Access Compliance Report

Public Rights-of-Way

| Intersection ID: 19817 | Main Street: MONROE_RD | Cross Street: TIMBER_SPRINGS_DR | Location: SE |
| ADA ID: 8830A41AEF57 | Ramp Type: Para | Initial Pass/Fail: Fail | Overall Compliance: No |

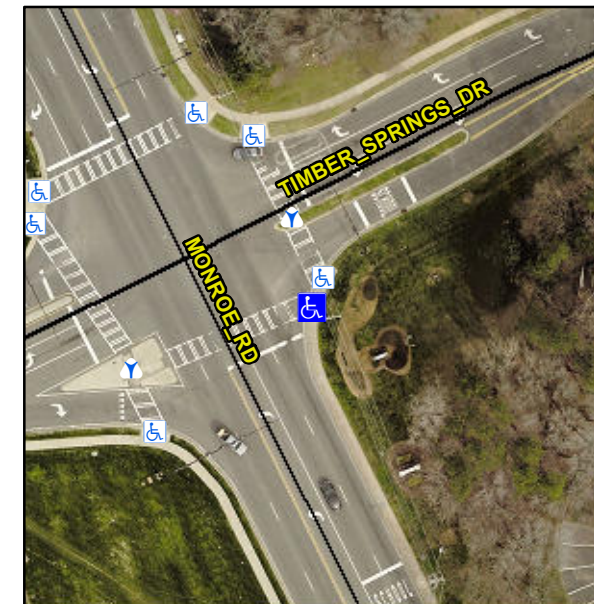
R304.5.1, R304.5.3, R304.3.2

| Compliance | Description | Data | Compliance | Description | Data |
|------------|----------------------|-------|------------|-----------------------------|------|
| No | Ramp Width LT (in) | 36.0 | No | Ramp Width RT (in) | 36.0 |
| Yes | Ramp Slope LT (%) | 5.1 | No | Ramp Slope RT (%) | 8.9 |
| No | Ramp XSlope LT (%) | 4.1 | No | Ramp XSlope RT (%) | 5.1 |

Remove & Replace Entire Ramp.
